Environmental Impact Statement for

Fort Belvoir, Virginia

Comments Received on the Draft EIS and Responses

Figure 1 – Variation in “Constrained” 2011 Build Volumes

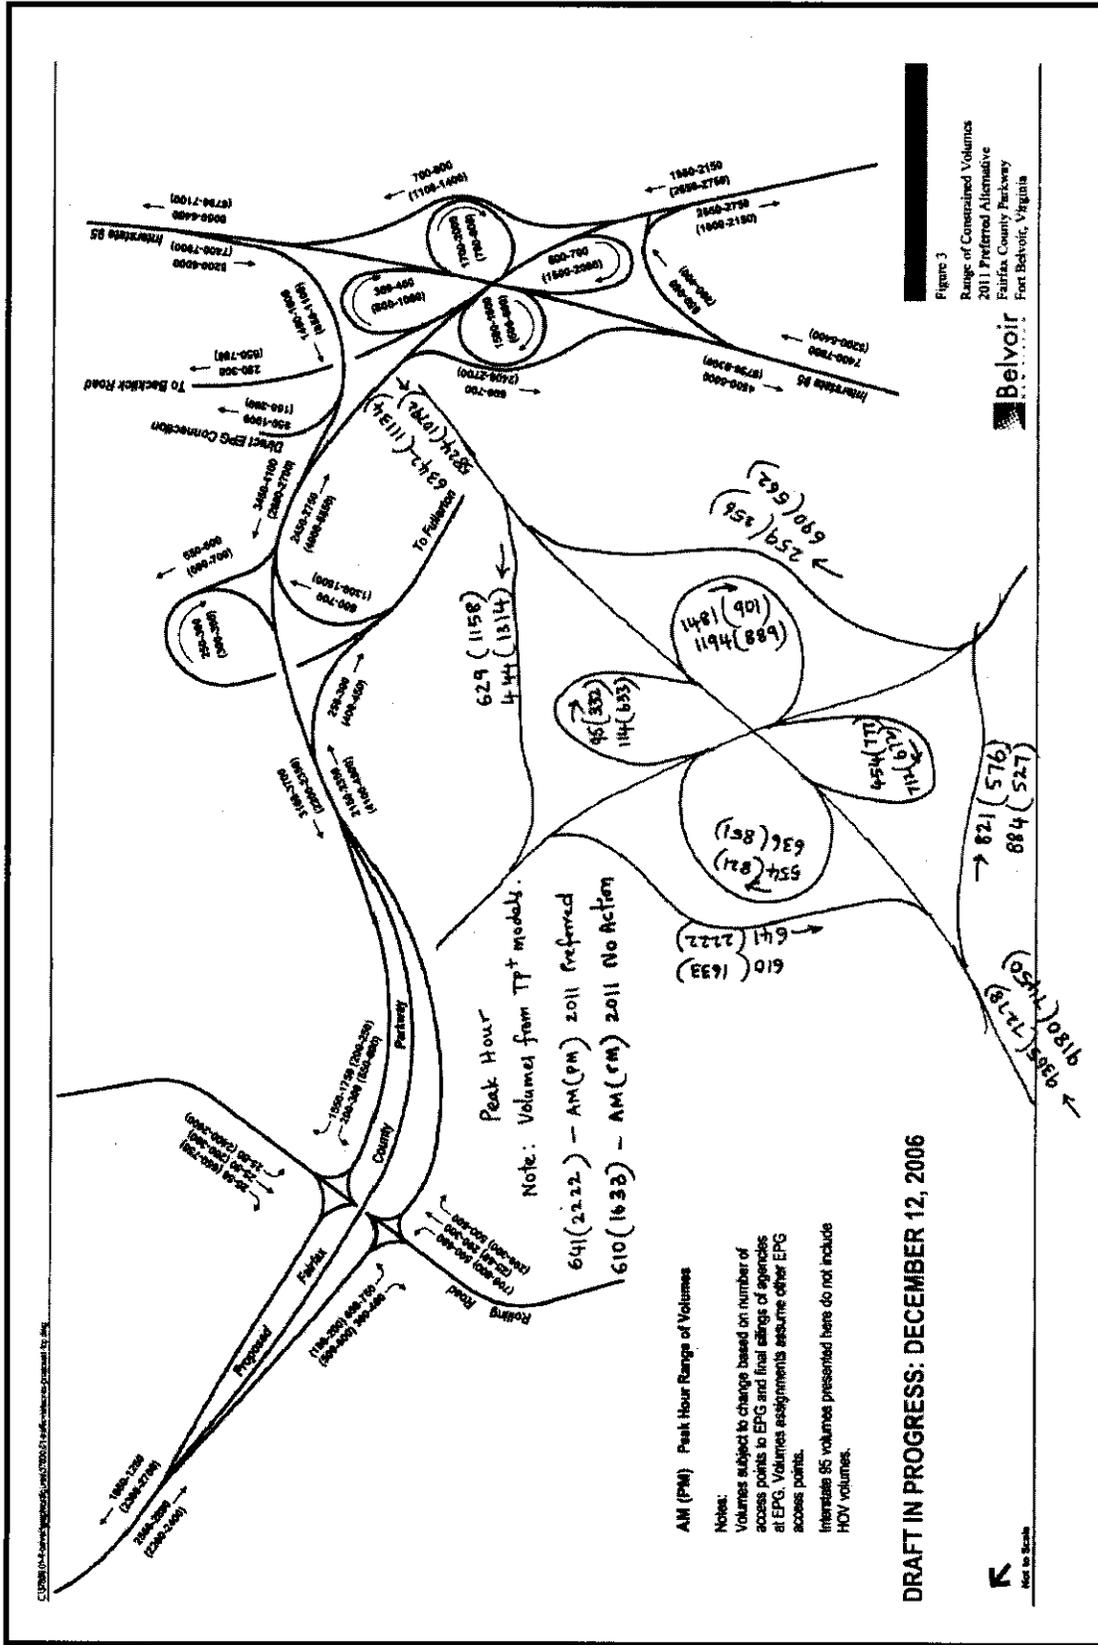
2. The turning movement volumes in the Synchro models vary substantially from the turning movement volumes generated by the planning models. The process for obtaining turning movement volumes for analysis was based on a factoring and smoothing process in accordance with the NCHRP 255 method for developing turning movement forecasts from computerized trip assignment data. Generally, we are in concurrence with this methodology although we have been unable to correlate the "seed" approach link volumes to the source volumes from the planning models. Figures 3a and 3b demonstrate an attempt to track the development of 2011 Build volumes at the US 1 / Telegraph Road intersection. Figure 3a demonstrates the representation of this intersection in the TP+ model, where it is analyzed as a 3-leg "T" intersection. Figure 3b is an attempt to cross reference seed volumes to turning movements generated by the planning model. In addition to the volumes failing to check, the "smoothed" intersection is given an additional southern leg not present in the planning model. Similar difficulties were encountered during attempts to validate the seeding process for other intersections as well.

Figure 3a – Turning Movements at US 1 / Telegraph

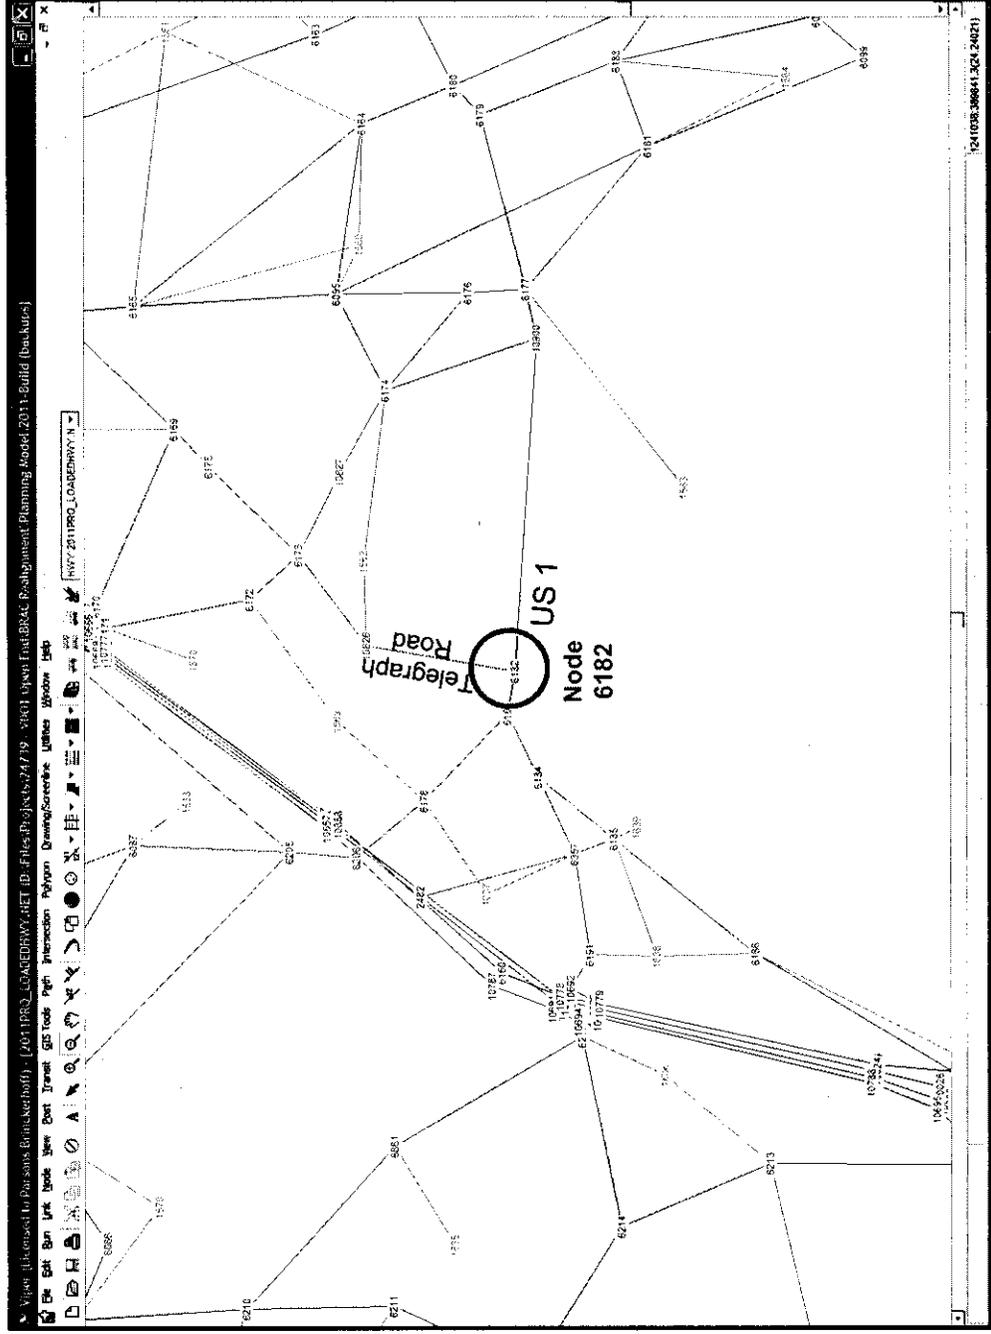
- No correlation between TP+ model and turning movement smoothing
